TO: US AND CANADA DEALER PRINCIPALS, SERVICE MANAGERS, PARTS MANAGERS AND SALES MANAGERS
RE: PRELIMINARY SERVICE INFORMATION FOR RECALL 156 VOLVO XC90 (MY2003-MY2006) WINDSHIELD WIPER ARM, REDUCED PERFORMANCE

VOLVO				TITLE:		GROUP: 36	NO: 156	
				Recall 156 Windshield Wiper Arm, Reduced Performance		ISSUING DEPARTMENT: Warranty		
Service Manager Bulletin						MODEL YEAR 2003-2006 XC90		CAR MARKET: United States, Canada
				REFERENCE BULLETINS: TNN# 36-156		DATE:		
YEAR	MONTH	DAY						
Service Personnel: read and initial.						2006	06	06
SERVICE MANAGER				WARRANTY ADMINISTRATOR				
				Page 1 of 3

SUBJECT: Recall 156 Windshield wiper arm, reduced performance
REFERENCE: VIDA, SMB 36-156

IMG-248064

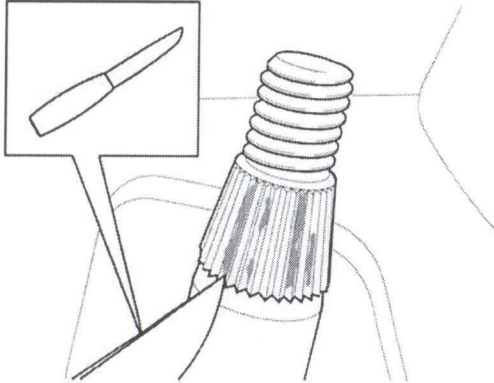
Caution! The splines of the drive shafts must be free from aluminum residue and dirt.

IMG-248225

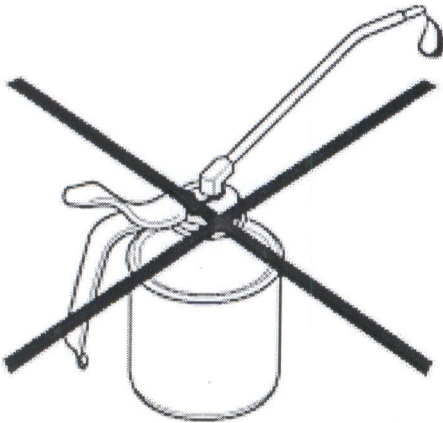
Caution! The splines and threads of the drive shafts must be completely free from oil products.

Thoroughly wipe clean and dry.

D3603089

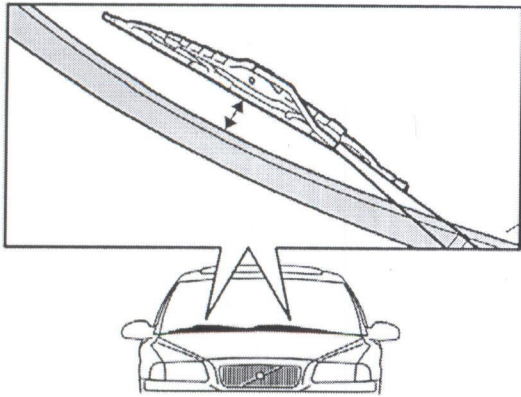
Transfer the wiper blades to the new wiper arms.

Note! Use new nuts.

Press the wiper arm onto the drive shaft.
Loosely screw the nut in place.
Adjust the wiper arm into the correct position.
See illustration.

Driver's side:

The distance from the center of the wiper blade to the upper edge of the trim strip must be 75 mm.

Passenger side:

The distance from the center of the wiper blade to the upper edge of the trim strip must be 90 mm.

Caution! Hold the wiper arms while tightening the nuts.

Tighten the nuts to 22 Nm + 90° angle.
Fit the protective covers.
